ADDENDUM

PROJECT: Waverly Lawson Park
Phase II Improvements
Waverly, Nebraska

AD-1

DATE ISSUED: Wednesday, September 10, 2014

From Sheet	S-101C	for CA use:
Drawing #	S-101C.1

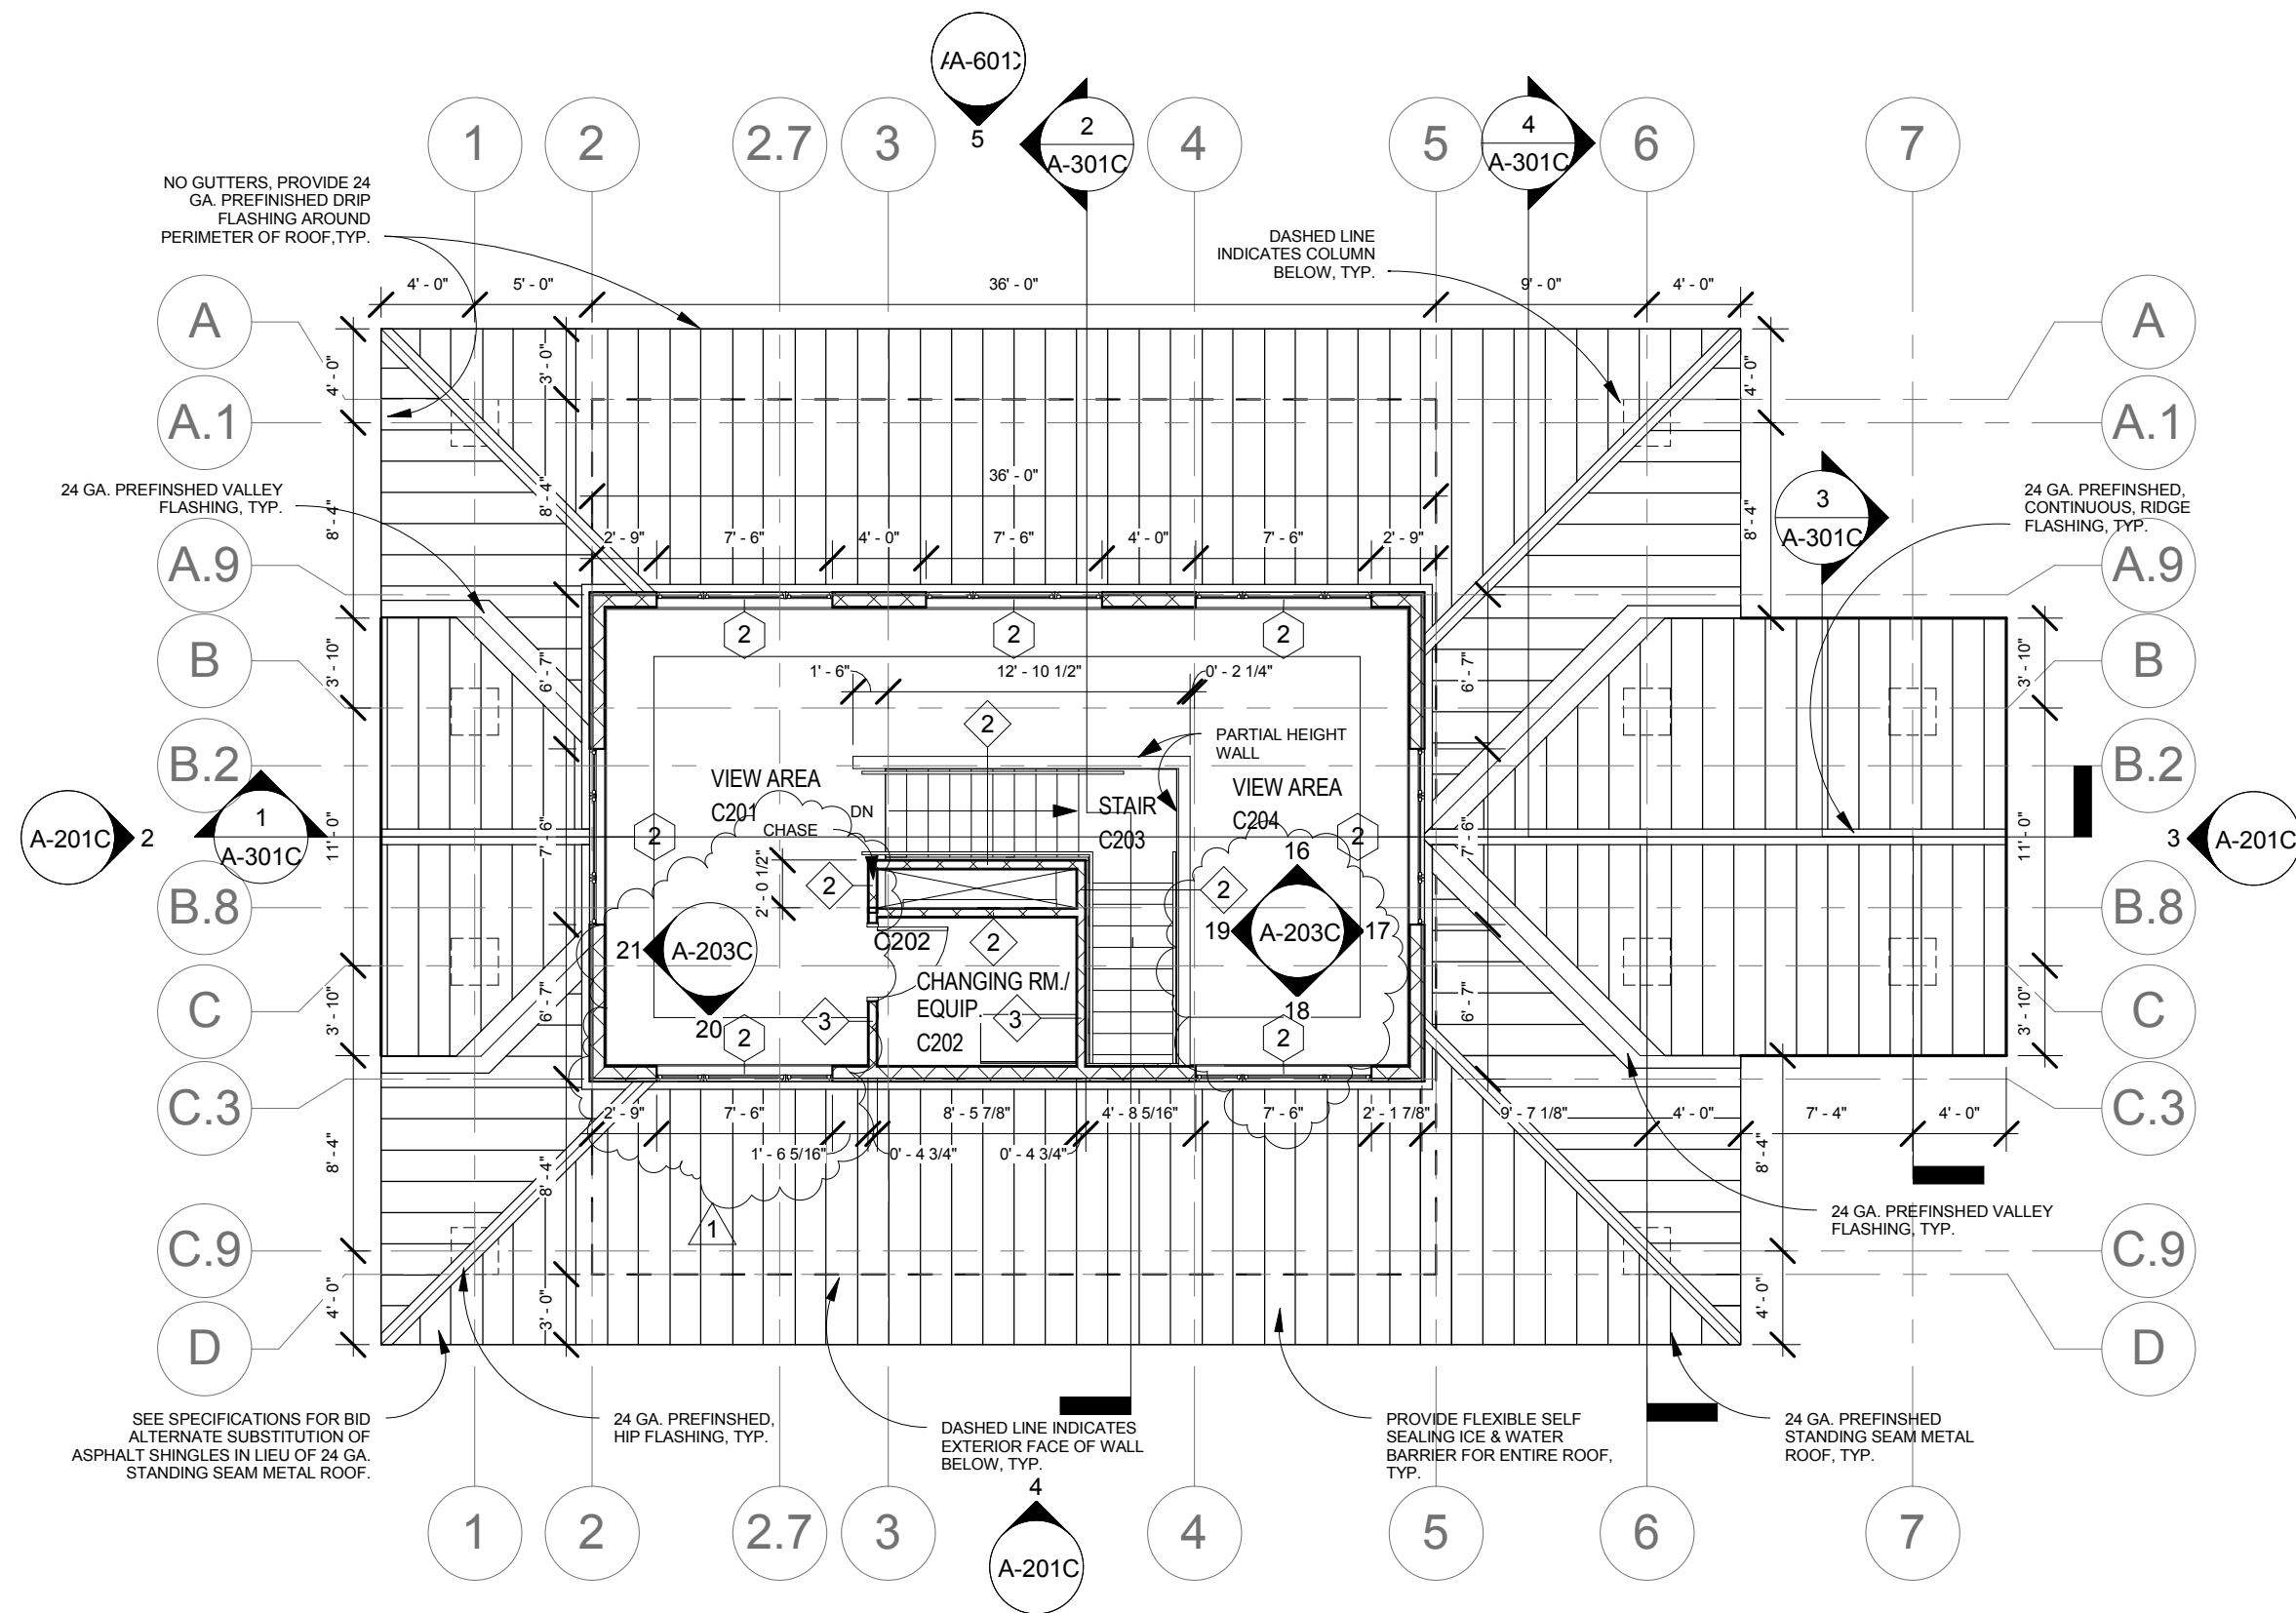
In reference to Sheet S-101C - Structural Framing Plans, interior frost slabs have been added to Foundation Plan 1. See clouded area on attached Supplemental Drawings S-101C.1.

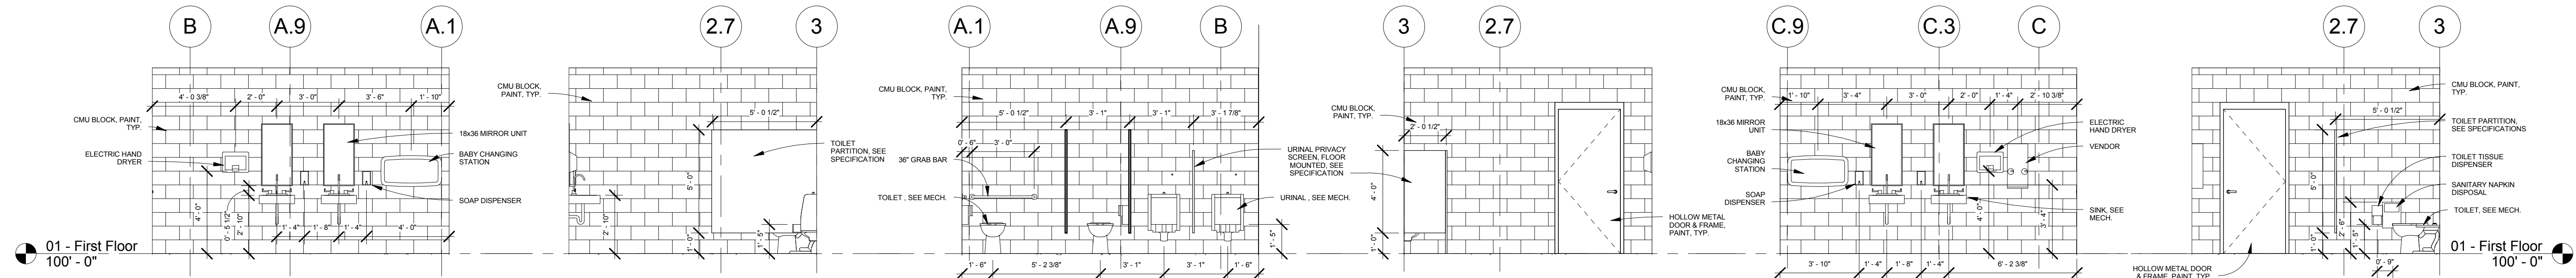
In reference to Sheet A-102C - Second Level Ceiling Plan, interior elevation reference tags have been added to the plan. See clouded area on attached Supplemental Drawing A-102C.1.

A-203C

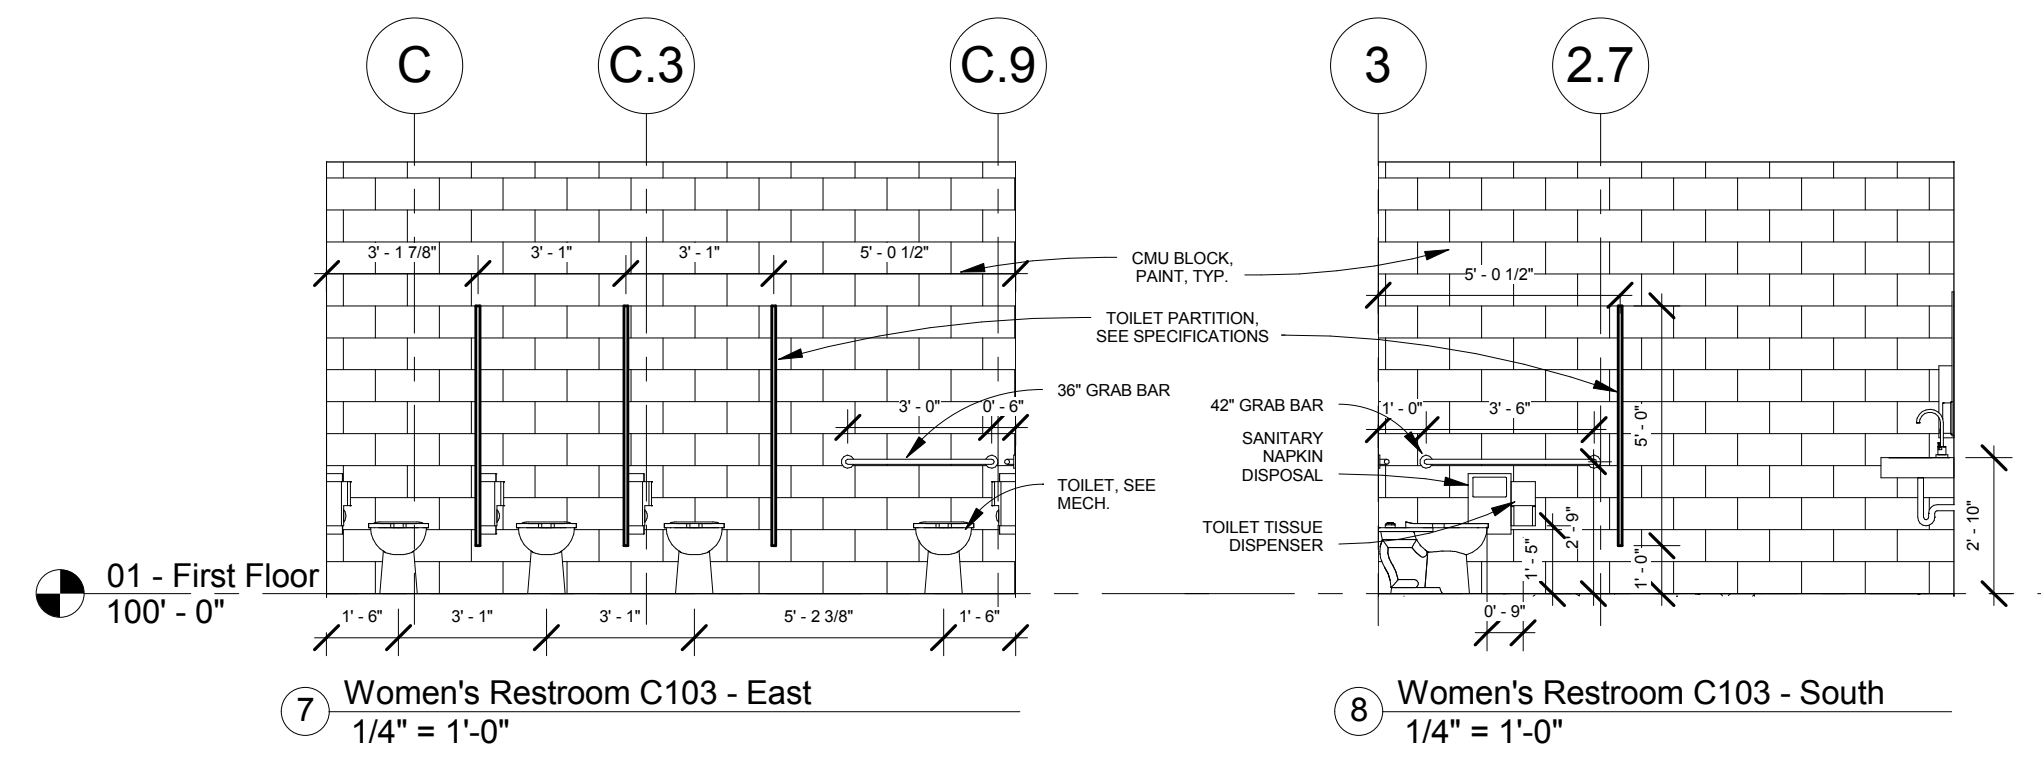
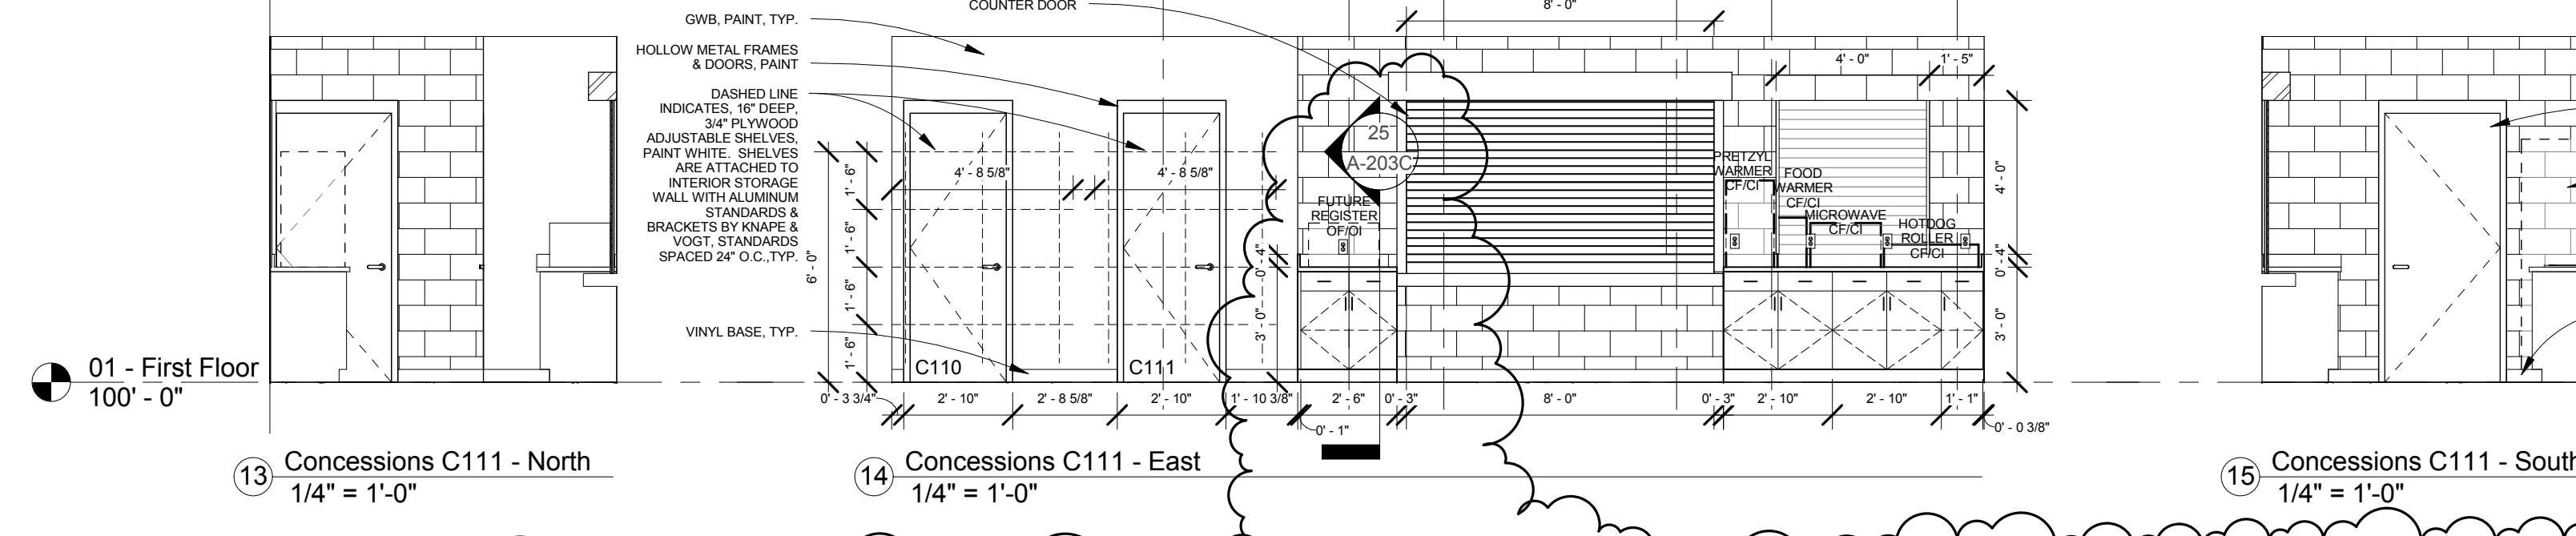
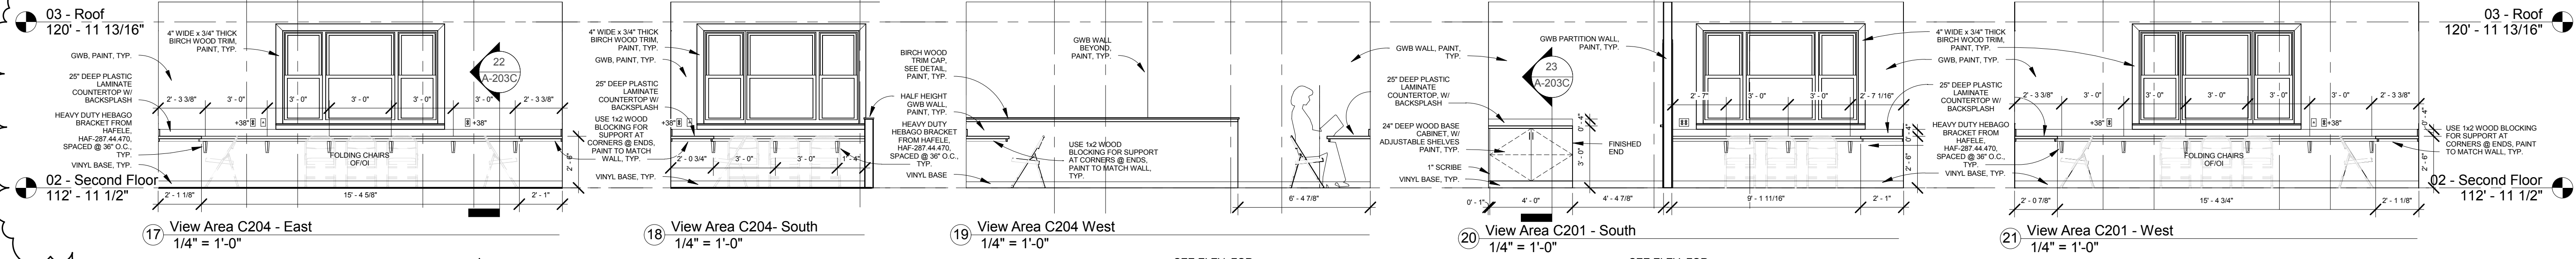
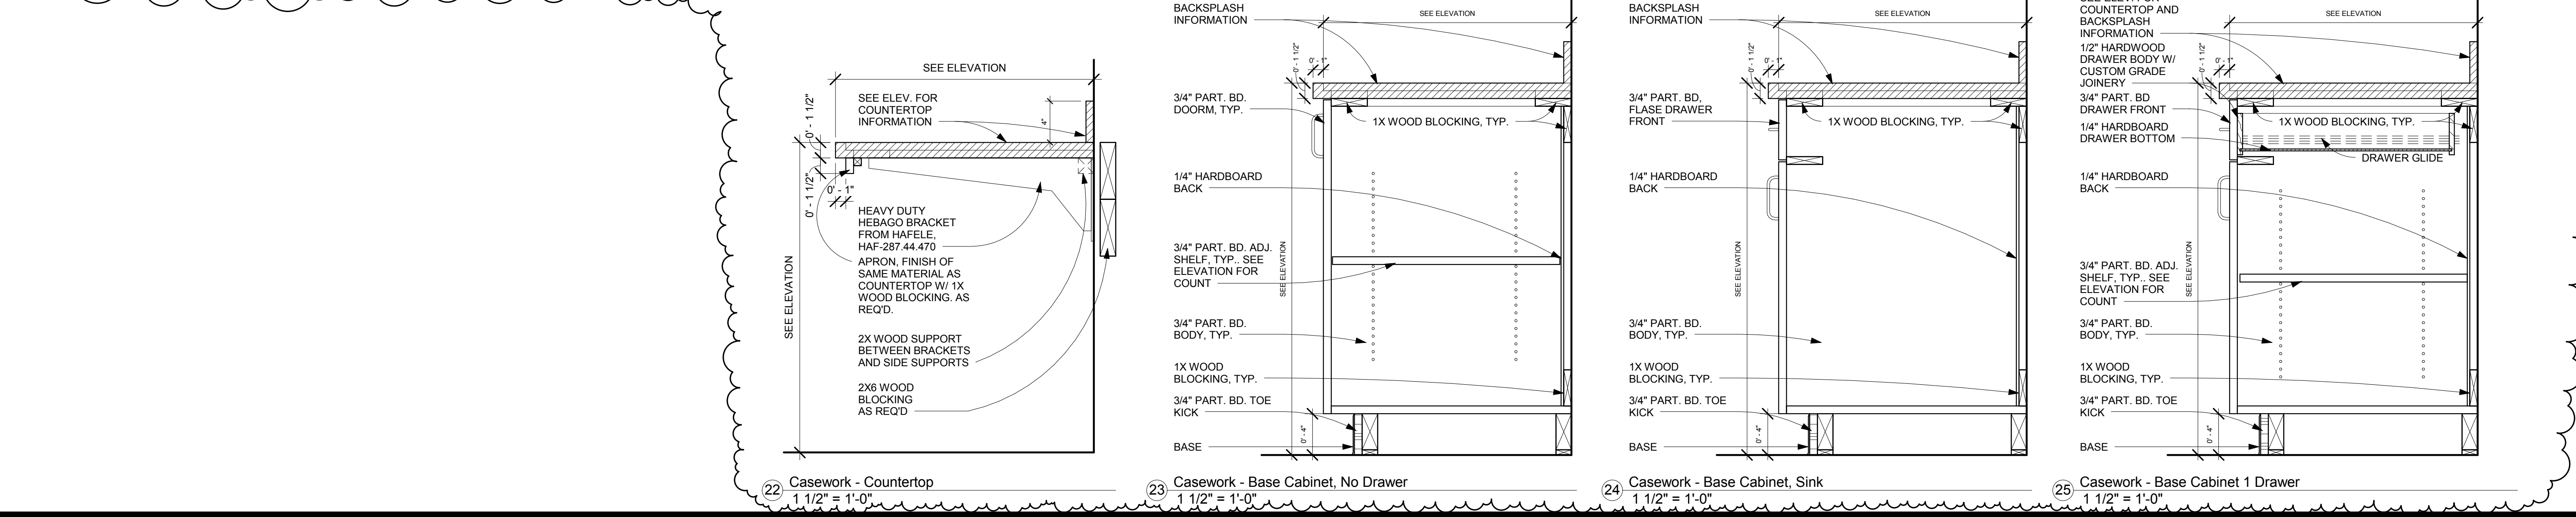
In reference to Sheet A-203C - Interior Elevations, casework section details were added to the sheet along with tag references to corresponding elevations. See clouded area on attached Supplemental Drawing A-203C.

In reference to Sheet A-203C - Interior Elevations, elevations 9 & 10 were revised. See clouded area on attached Supplemental Drawing A-203C.
